CON	TEC CORPORATION					
Title Mi	AIN BOARD W_RF [ SF	RC 350	MODEL]			
Size C	Document Number Designer = Herbert L. Santeliz					Rev 04
Date:	Monday June 12 2006	Sheet	2	of	2	•

CON	NTEC CORPOR	RATION						
Title W	IRELINE	KEYPAD	[	MODEL	SRC	-350	]	
Size B	Document Number Designer = Herbert L. Santeliz					Rev 04		
Date:	Tuesday,	May 23, 2006		Sheet	1	of	2	•

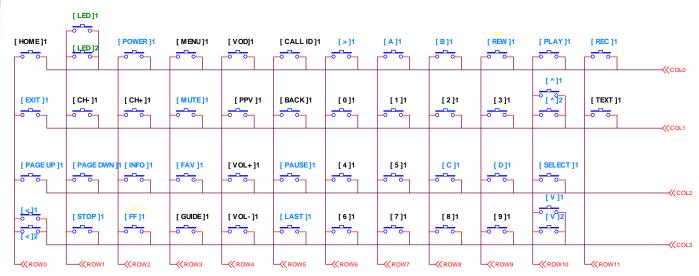
SCHEMATICS REV	CHANGE HISTORY	REASON FOR CHANGE	NOTES
Rev 02	Remove R17 and Q4 signal is inverted in software to trigger the PNP transistor Q3	Remove R17 and Q4 signal is inverted in software to trigger the PND transistor Q3	
Rev 04	Change Component Values for CT, C10, C9, R18 CT = 470pf Ct0 = 10pf Ct = 23.3X Chumns
